Access Compliance Report

Public Rights-of-Way

(Curb Ramps)

Intersection ID: 30478	Main Street: CREEK_TURN_DR	Cross Street: EBULLIENT_ST	Location: SE
ADA ID: 96F35913F3FF	Ramp Type: PerpDiag	Initial Pass/Fail: Fail	Overall Compliance: No
Severity Score: 48.75			
Codes/Mitigation Info/Possible Solution		Field Measurements/Component Compliance

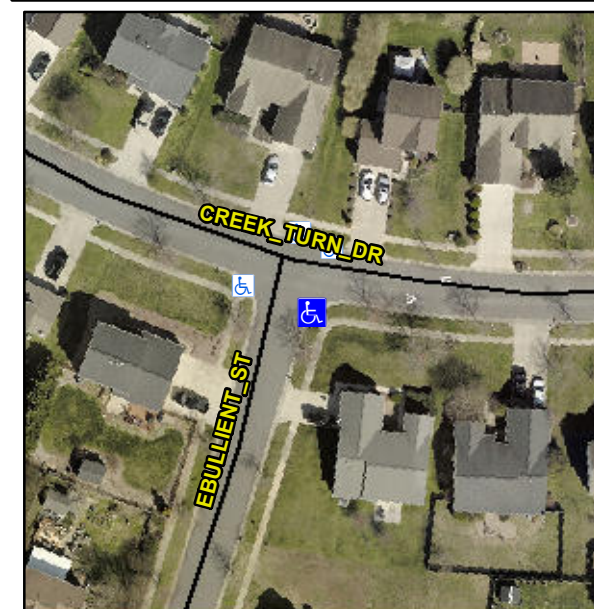
R304.5.1, R304.2.2, R304.5.3

Compliance	Description	Data	Compliance	Description	Data
N/A	Ramp Length (in)	81.0	No	Ramp Slope (%)	10.9
No	Ramp Width (in)	30.5	No	Ramp XSlope (%)	4.2
N/A	Flare Type LT	N/A	N/A	Flare Type RT	N/A
N/A	Flare Slope LT (%)	N/A	N/A	Flare Slope RT (%)	N/A
N/A	Flare Traversable LT?	N/A	N/A	Flare Traversable RT?	N/A
N/A	Landing Length (in)	N/A	N/A	DWS Provided?	N/A
N/A	Landing Width (in)	N/A	N/A	DWS Contrast?	N/A
N/A	Landing Slope (%)	N/A	N/A	DWS Length (in)	N/A
N/A	Landing X Slope (%)	N/A	N/A	DWS Full Width?	N/A
N/A	Landing Curb? (Y/N)	N/A	N/A	DWS Offset (in)	N/A
N/A	Shared Landing?	N/A			
N/A	Gutter Ponding?	N/A	N/A	Gutter Slope (%)	N/A
N/A	Gutter Lip Ht (in)	N/A	N/A	Gutter X Slope (%)	N/A
N/A	Painted X Walk1?	No	N/A	Painted X Walk2?	No
	X Walk 1 Direction	To NE		X Walk 2 Direction	To NW
N/A	X Walk 1 Width (in)	N/A	N/A	X Walk 2 Width (in)	N/A
	X Walk 1 Slope (%)	4.4		X Walk 2 Slope (%)	2.6
	X Walk 1 X Slope (%)	0.8		X Walk 2 X Slope (%)	2.4

N/A	Ramp inside XWalk1?	N/A	N/A	Ramp inside XWalk2?	N/A
	Road Slope (%)	2.3	N/A	Clear Space?	N/A
	Road X Slope (%)	6.3	N/A	Clear Space to XWalk (in)	N/A
N/A	Any Obstructions?	N/A	N/A	Storm Grate/Utility Hazard?	N/A
	Obstruction Type			Storm Grate/Utility Type	
		N/A			N/A
			Yes	Surface Condition? (G/P)	Good

Remove & Replace Curb Ramp With Two New Directional Ramps or Equivalent.
